Save the Mary River Coordinating Group

Re: Submission on the draft Terms of Reference for the EIS - Traveston Crossing Dam proposal.

The purpose of this submission is to provide feedback on the Draft Terms of Reference (ToR) for an Environmental Impact Statement dated December 2006 regarding the proposed Traveston Crossing Dam.

Figure 1. Trend in annual flow rate in the Mary River at the Bellbird Creek confluence.

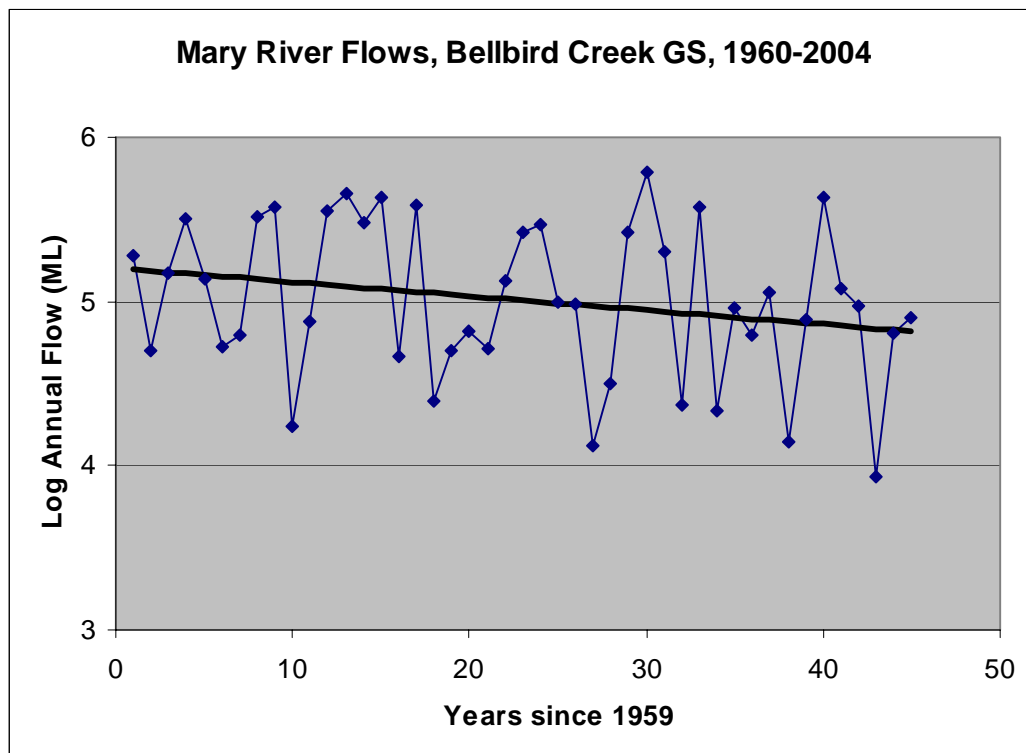
There is good evidence that streamflows in the Mary River have been declining over the last 40 years. This is in line with most of the current thought about cyclic climate variability and climate change in S.E. Qld. Figure 1 shows recorded streamflow in the Mary River at a point in the upper catchment that has not experienced any major upstream infrastructure development during the period of record. (It is possible that overland flows may have been reduced because of land use or groundcover changes). However, streamflow is the actual resource that is harvested by dams, and these data indicate that annual flows in the river at that location have reduced from an expected value of around 157 GL/annum to an expected value of 66 GL/annum since 1960.

Figure 2. Simulated annual stream flow data for the 'no development' IQQM scenario at Dagon Pocket. 11 year and 22 year moving averages are shown. Derived from 'Appendix A' of the Environmental Flows and Scenario Implications Report for the Water Resource Plan (Mary Basin) 2005.

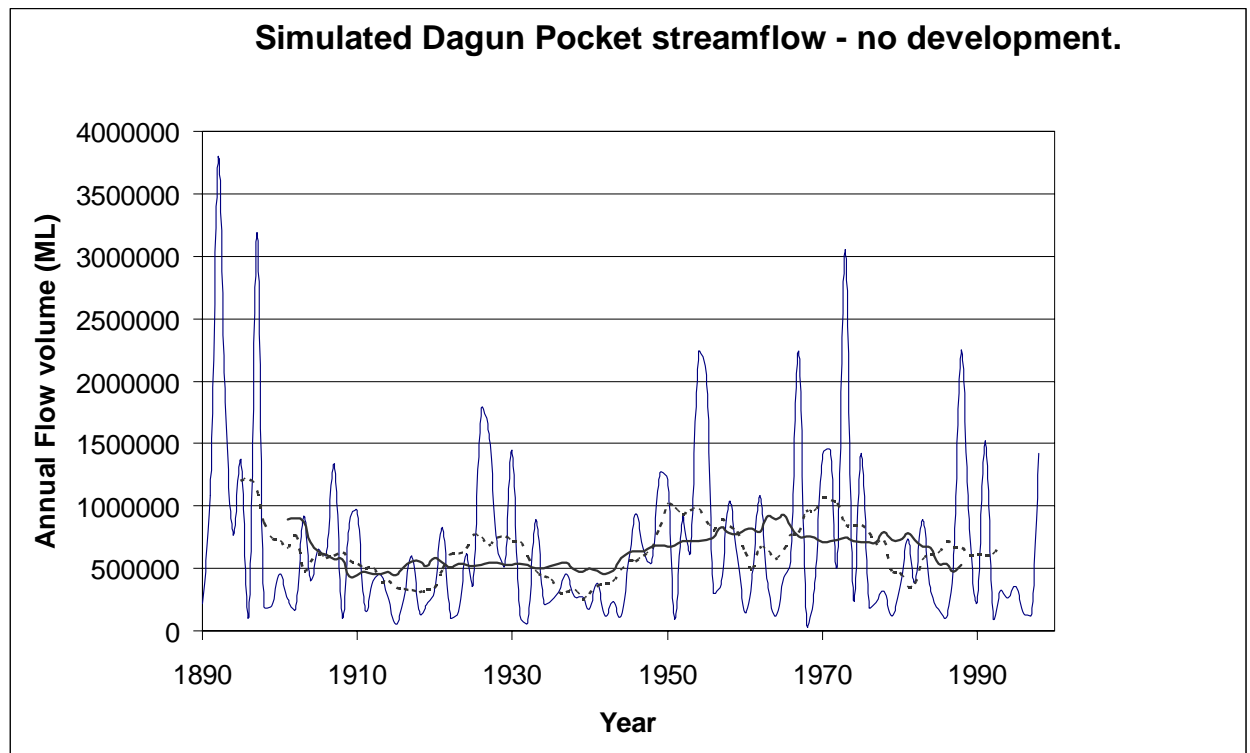
The IQQM (DLWC 2004) modelling used to formulate the draft Water Resource Plan for the Mary Basin (DNR 2005) offers an opportunity to simulate the natural flows that would have existed in the river at the proposed damsite, in a non-developed 'natural' state over the simulation period of 1890 to 1999. These results are shown in figure 2. A striking feature is the large variability in flows. There does seem to be evidence of a cyclical pattern in the flows. An attempt to illustrate this is shown on the graph by also showing 11 year and 22 year moving averages. It seems that annual streamflows at the damsite would have been very high at the

end of the 19th century, generally low during the first half of the twentieth century, high during the mid to late 20th century and the pattern suggests that low streamflows may generally be expected for the late 20th century/early 21st century.

Figure 3. Storage behaviour curve for scenario S1-minimal loss.

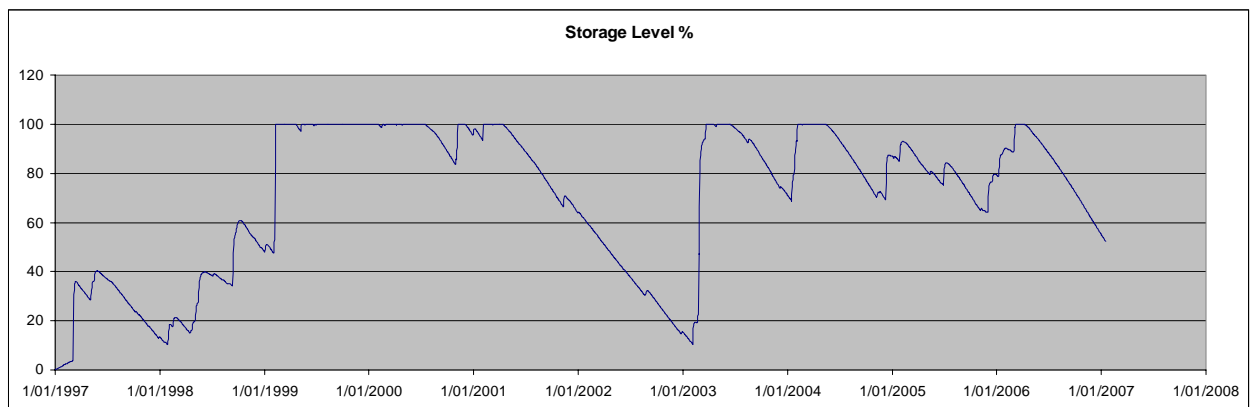
Even with these generous assumptions, and not having to provide any water at all for downstream users, the dam operates at the margin of failure and has severe impacts on downstream flows, reducing median daily flows a further 35% below the existing (already drought affected) flow regime.

Figure 4. Storage behaviour curve for scenario S1-WRP.

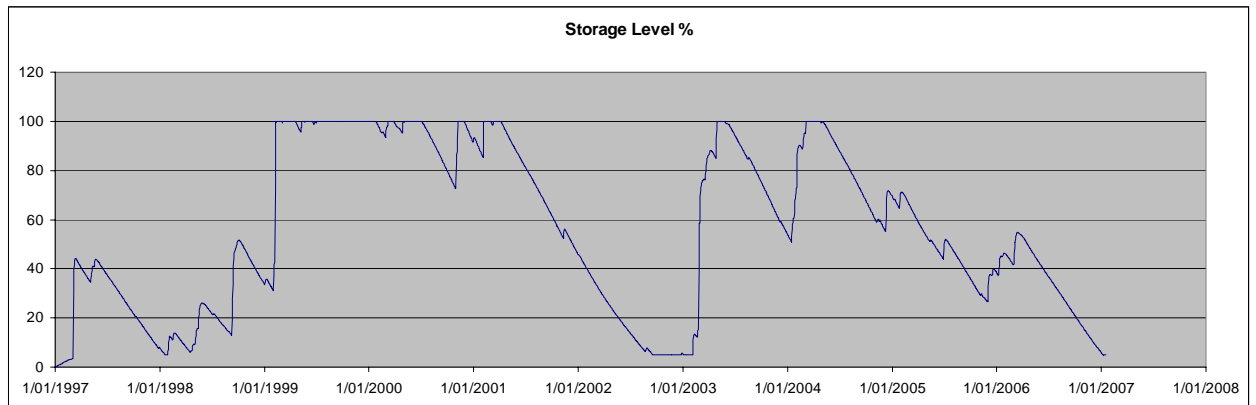
With more realistic assumptions, but still not leaving any water for downstream users on top of the environmental flow releases, it is fairly clear that the dam would have experienced a convincing yield failure in late 2002 and in early 2007.

Figure 5. Storage behaviour curve for scenario S2-WRP.

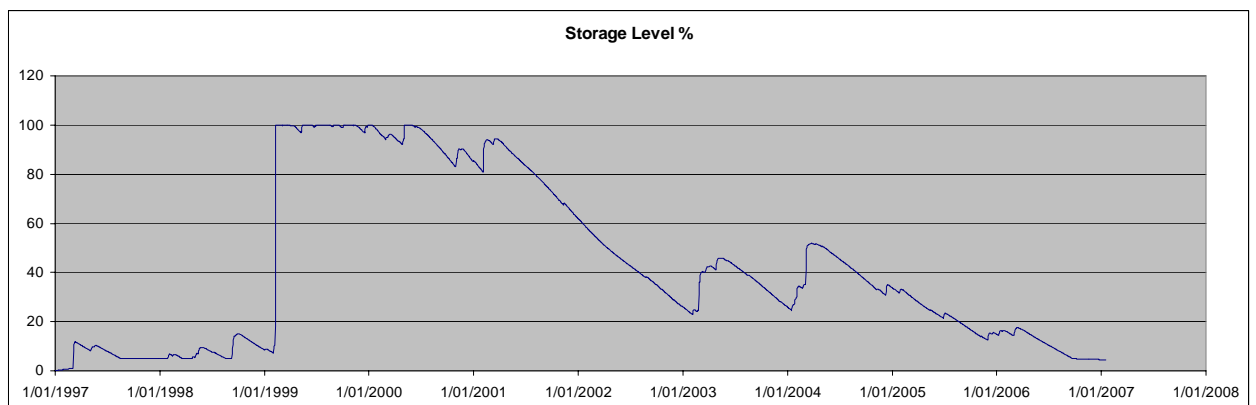
It appears that even the larger stage 2 dam, with a moderate target yield of 110GL would have also experienced a convincing yield failure by the end of 2006.

Figure 1: Electrical conductivity levels recorded during the 2006 & 2002 Catchment Crawls

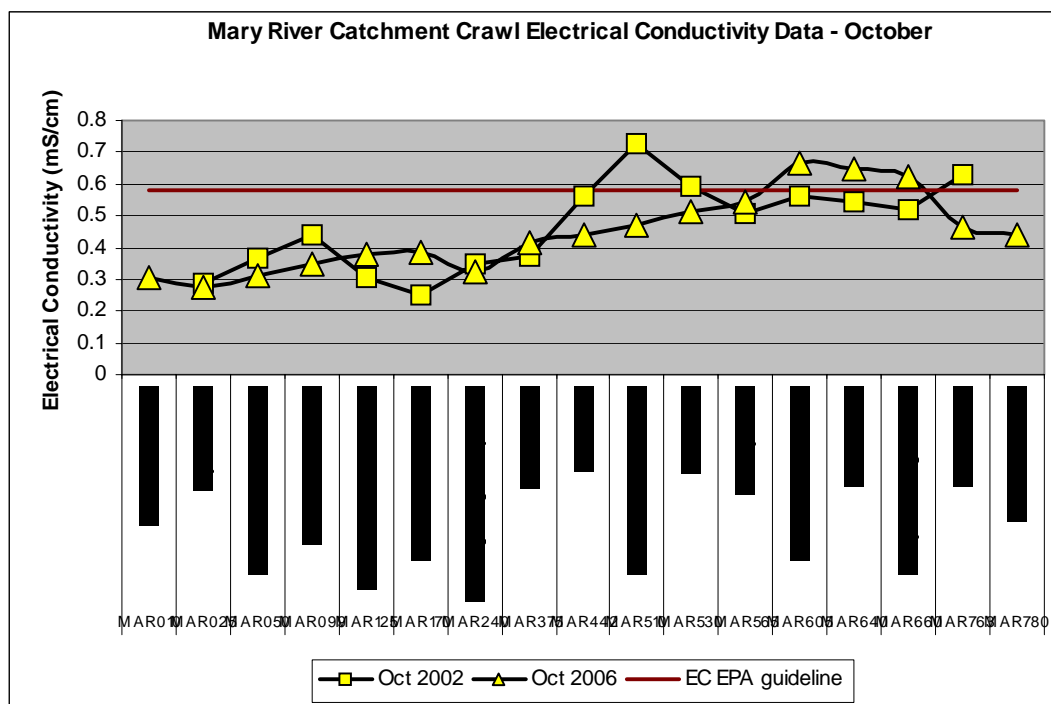
In times of low flow, salinity (EC) levels in the river downstream of the dam already exceed the Queensland Water Quality Guidelines for the Mary River (2006). Figure 1 shows EC levels recorded by the MRCCC while travelling down the river during the annual catchment crawl in October 2006, indicating where this occurs. (from Wedlock 2006)

Figure 2. The overall correlation between reduced flow and increasing salinity at Fisherman's Pocket. Note the large number of EC readings above 572 $\mu\text{S/cm}$.

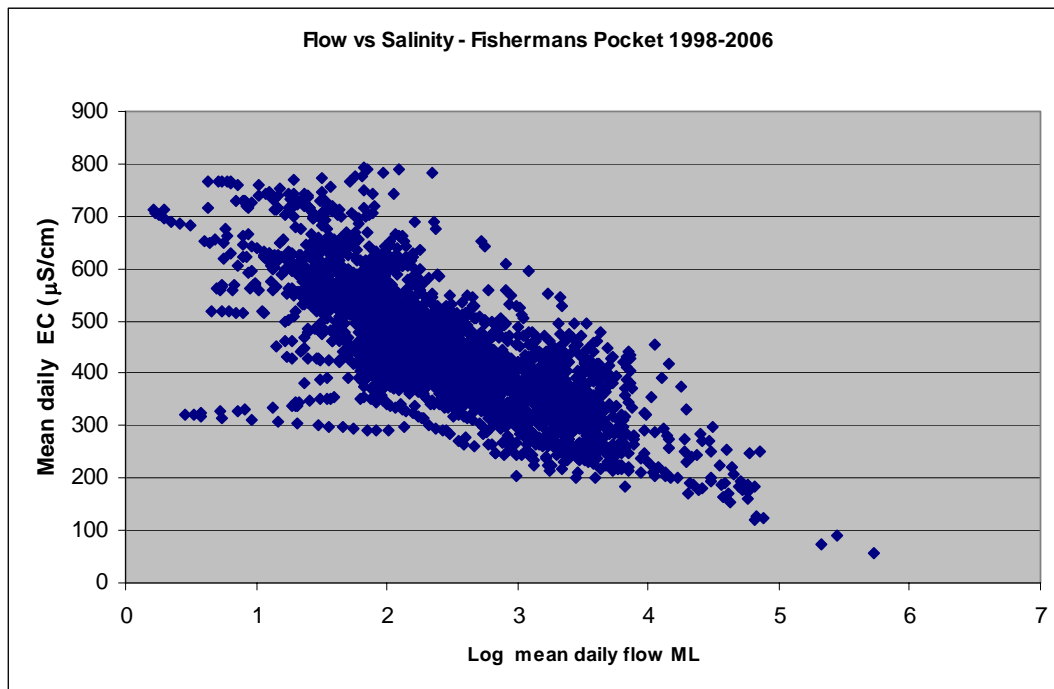
At a given point in the river, there is a strong negative correlation between EC levels and flow, as shown in figure 2 for the stream gauging station at Fisherman's Pocket. It is particularly clear if you investigate a particular flow sequence (to remove compounding long term time trends), as illustrated in figure 3.

The 80 percentile figure for Southern Coastal Streams from Appendix G of the Queensland Water Quality Guidelines is 572 $\mu\text{S}/\text{cm}$. Figure 2 also shows that when flows are low, EC levels already reliably exceed this figure.

Figure 4. Time trend in salinity levels at Fisherman's Pocket.

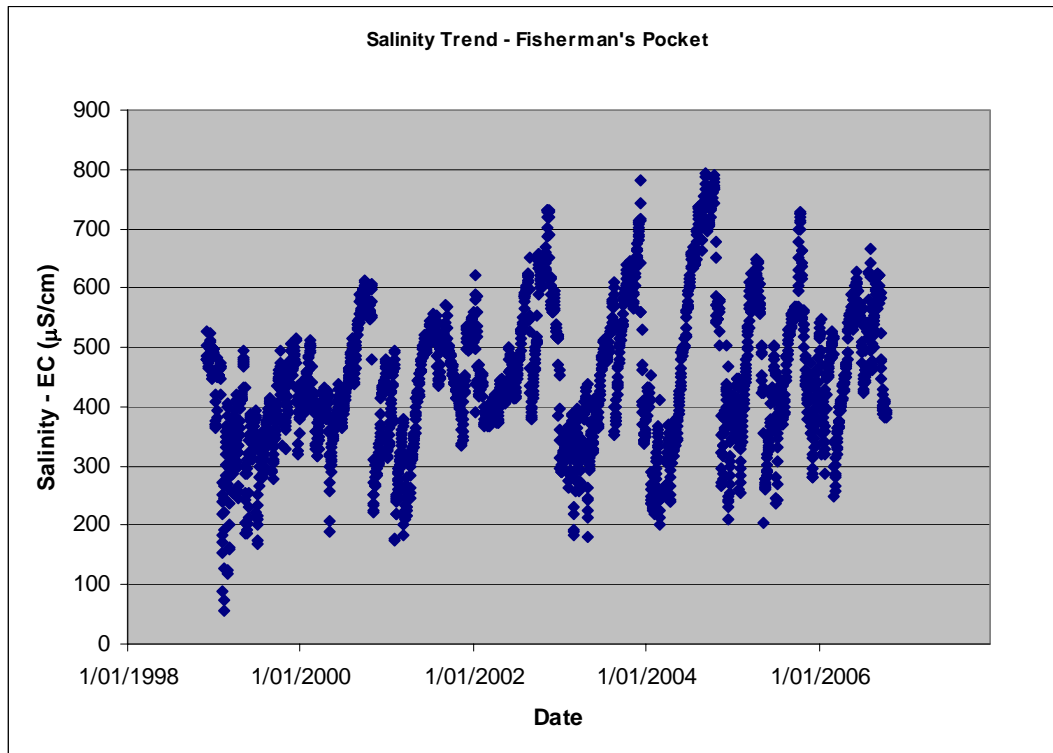
EC levels may also be showing a generally increasing long term trend with time, as shown in figure 4.

Figure 5. Modelled increase in outflow concentration from the storage, Traveston Crossing Stage 1.

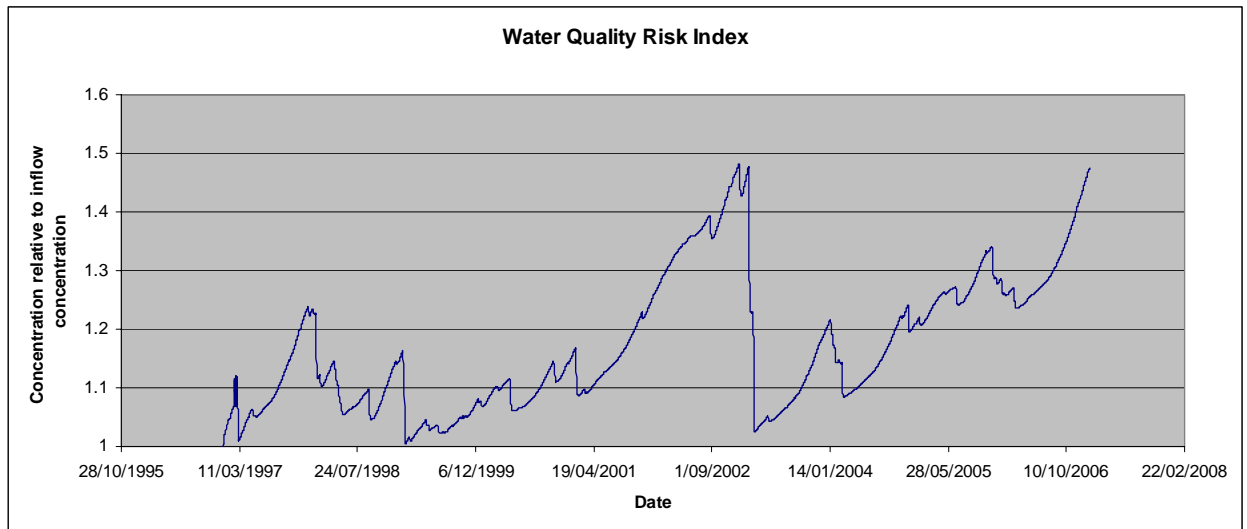
In addition to the effects on water quality resulting from reduced downstream flow, the dam itself would play a direct role in concentrating contaminants. A rudimentary water quality model was incorporated into the daily time step model described in Burgess 2007 used to investigate the storage and yield behaviour of the dam. This calculates the effect of evaporation and seepage from the storage on concentrating substances that come into the storage in the dam inflow. Figure 5 shows the effect of a stage one-sized storage (S1 minimal loss scenario) on concentrating pollutants in the storage over the 1997 to 2007 simulation period. Concentrations in the storage are increased to nearly 50% above the concentration in the inflow at times within this short 10 year period. This has major implications for water quality in the storage and in the downstream flows from the dam.
